SUBJECT: **NEW VEHICLE DEMONSTRATION / DELIVERY HOLD**
Update Prior to Sale 16U32 – Supplement #2
 Certain 2017 Model Year F-250 to F-750 F-Super Duty Vehicles Equipped with a
 6.7L Diesel Engine
 Engine Oil Pressure Inspection

REF: **NEW VEHICLE DEMONSTRATION / DELIVERY HOLD**
Update Prior to Sale 16U32
 Dated December 30, 2016

New! REASON FOR THIS SUPPLEMENT

FIGURE 11

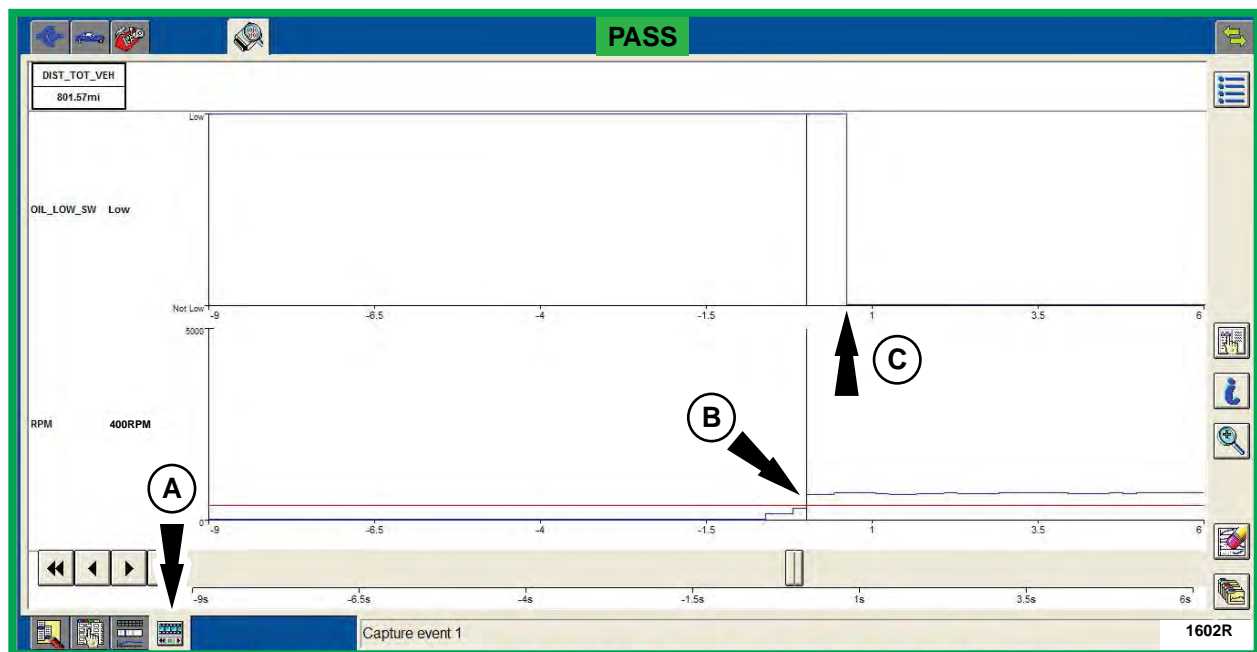
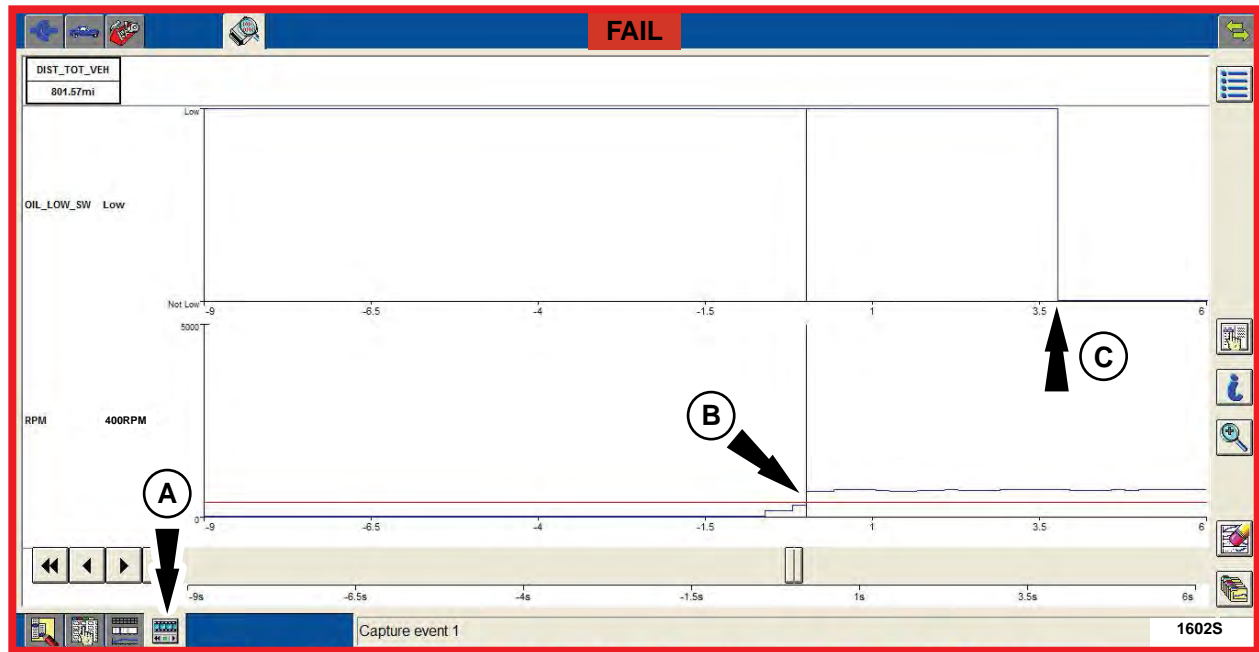
10. Evaluate the recording data. See Figures 11 and 12.

A. Select the Playback Display button to view the IDS recording.

B. The recording automatically started when the RPM PID crossed the 400 RPM limit. This represents 0 (zero) seconds on the graph.

C. Observe when the OIL_LOW_SW PID switched from "Low" to "Not Low".

- If the time is less than **3.25 seconds** the inspection is a PASS, no additional service is required.
- If the time is greater than **3.25 seconds** the inspection is a FAIL, and the engine front cover must be replaced following the procedures in Workshop Manual (WSM) Section 303-01C.
 - To place an order for the engine front cover, submit a VIN-specific Part Order contact via the SSSC Web Contact Site. The Part Order must include a file attachment containing a screen shot of the IDS recording demonstrating the fail condition. Attachments must be 1MB or smaller.
 - Send the IDS session file to Ford. See GSB G000070 - How To Send An IDS Session File Containing Recordings.
